RE: Structural Evaluation Observations and Recommendations of the Mosaic School Building at 1499 W. Main St. in Decatur, Illinois.

DPS - Mosaic School Structural Evaluation Project Number: 23-4047

ATTACHMENT 1

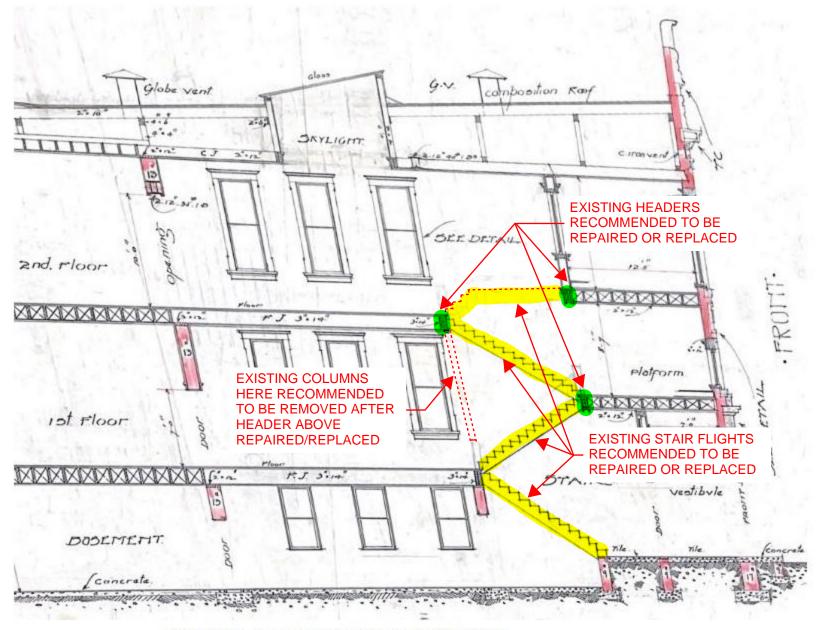
- 3. The two (2) timber column supports at the 1st floor landing that support the 2nd floor landing and stringer bearing are leaning or deflecting excessively in the north/south direction. It appears as if these two (2) columns are approximately 6x6 timber posts and were likely not original to the design of the stair and support system because they are not in the original plans or on the other middle stair
